Operable Unit 2 Groundwater Treatment System Evaluation and Optimization Report

Former Fort Ord, California

Report Date:September 2021Report Version:Draft Final

OU2 Groundwater Treatment Plant Schematic

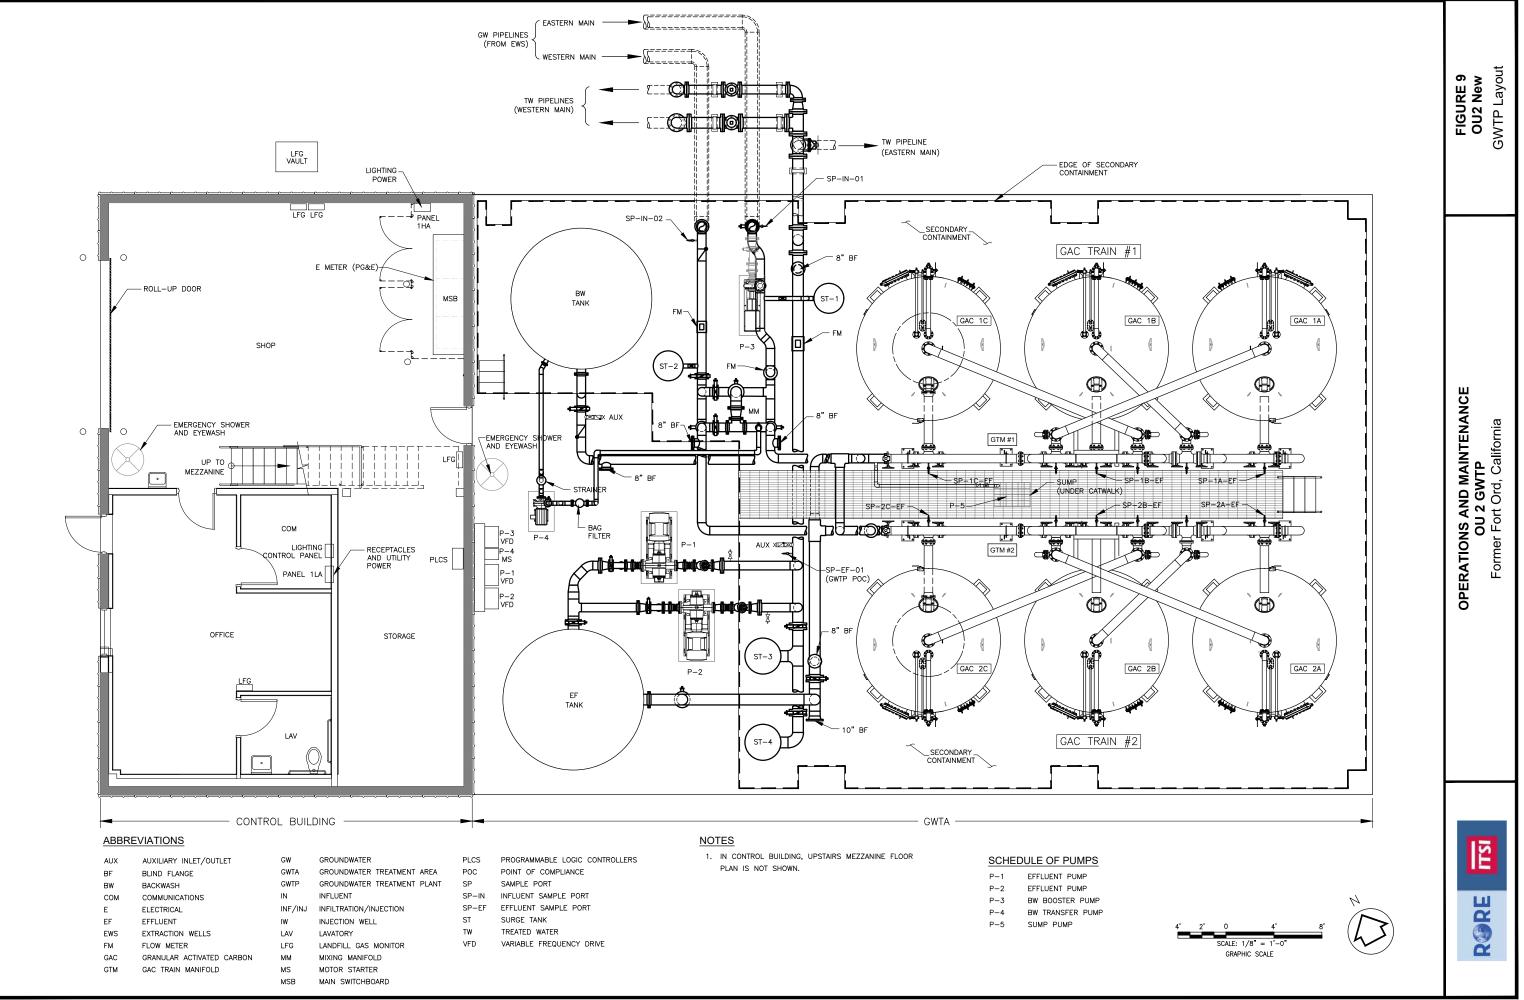
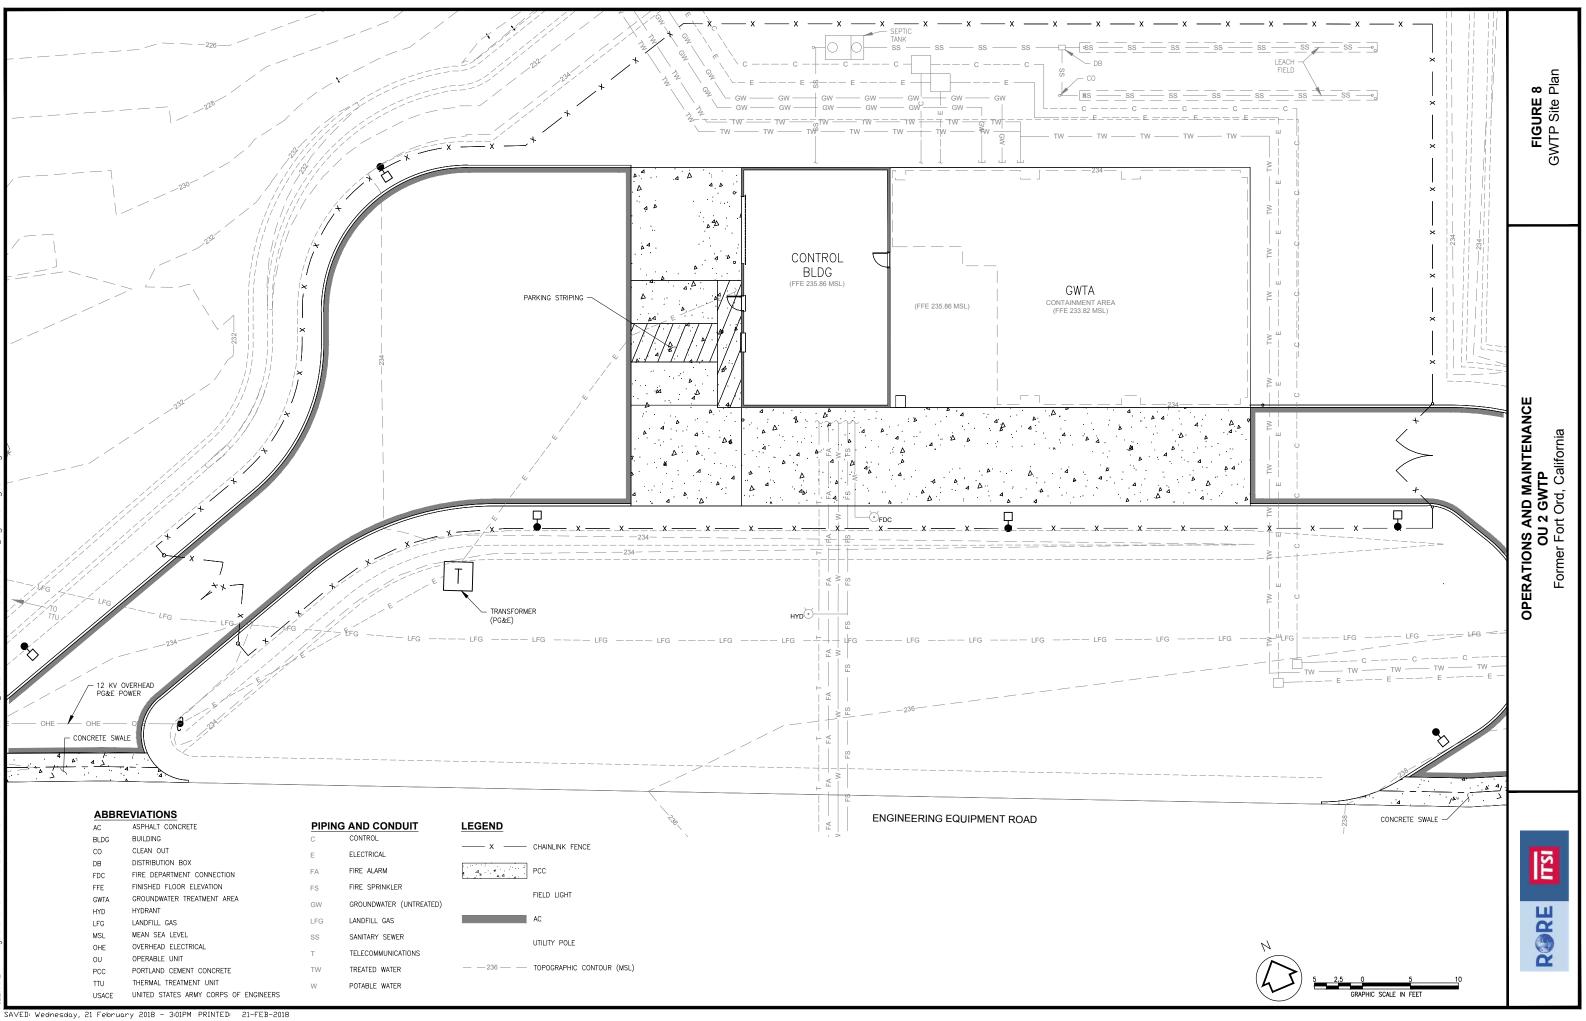
SPECIFIC COMMENT 1: Section 2.3, Groundwater Treatment Plant, Page 8: The first sentence of the second complete paragraph states, "Treated water from the GAC system is conveyed to an HDPE effluent tank (Figures 7 and 8);" however, the effluent tank is not shown on Figure 7 (Groundwater Treatment Plant Site Plan). The third paragraph also references Figures 7 and 8 (OU2 New GWTO Layout) as depicting the effluent pumps, but Figure 7 does not present this information. Please revise the text to cite the second figure that includes the effluent tank and effluent pumps.

RESPONSE TO SPECIFIC COMMENT 1: Based on comments from the California Department of Toxic Substances Control (see Appendix C), one figure was added and figures were reordered and renumbered. As a result, the text in Section 2.3 was corrected to reference Figure 7 (OU2 Groundwater Treatment Plant Schematic) and Figure 9 (OU2 New Groundwater Treatment Plant Layout).

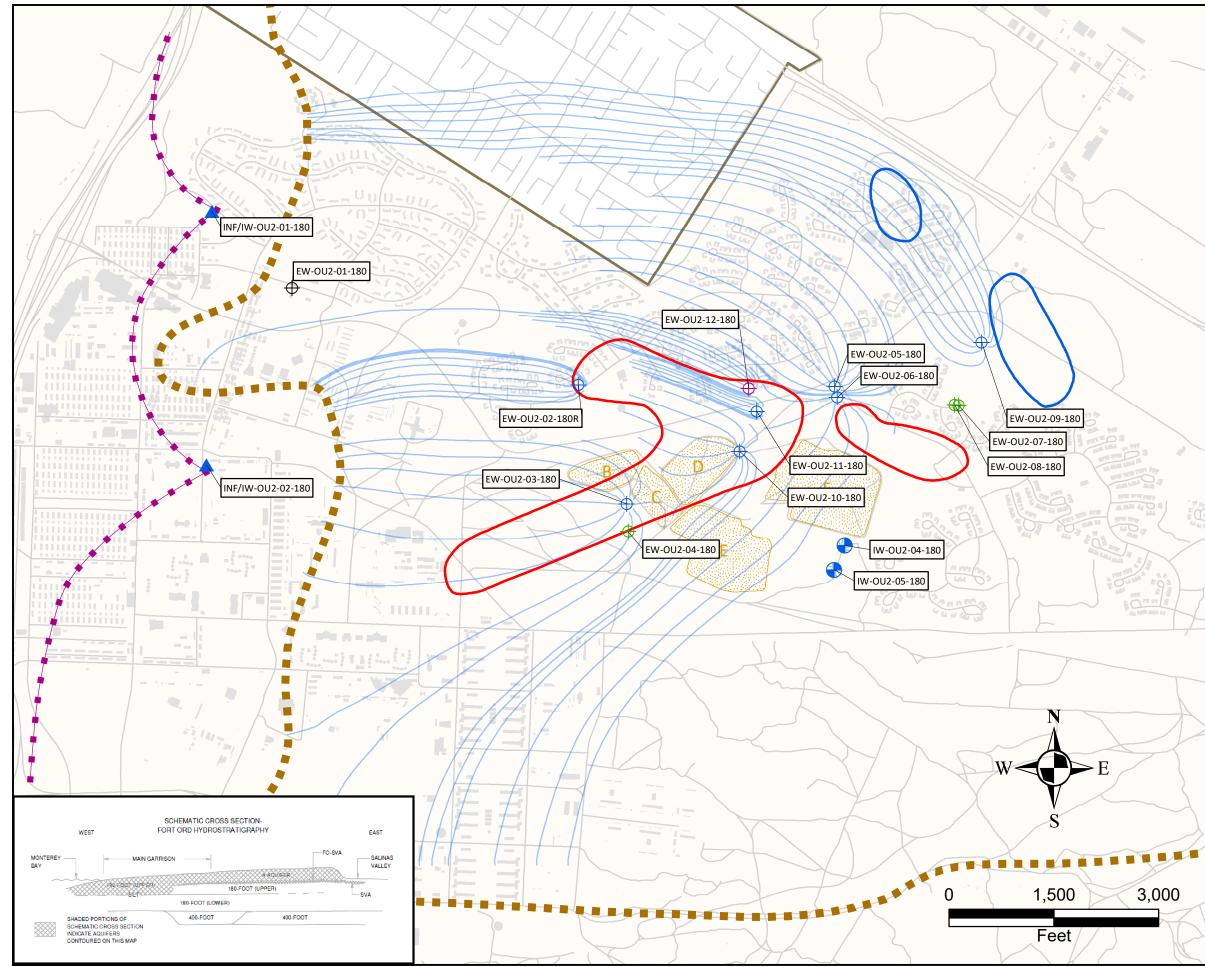
ESPO COMMENT 1. <u>Section 1.3.3 (Geology and Hydrogeology)</u>: Please include the Hydrostratigraphy inset on Figures 13 and 15 as a separate figure in the Report and please cite it in this section. It is very difficult to picture the hydrostratigraphy using only the text description provided in this section.
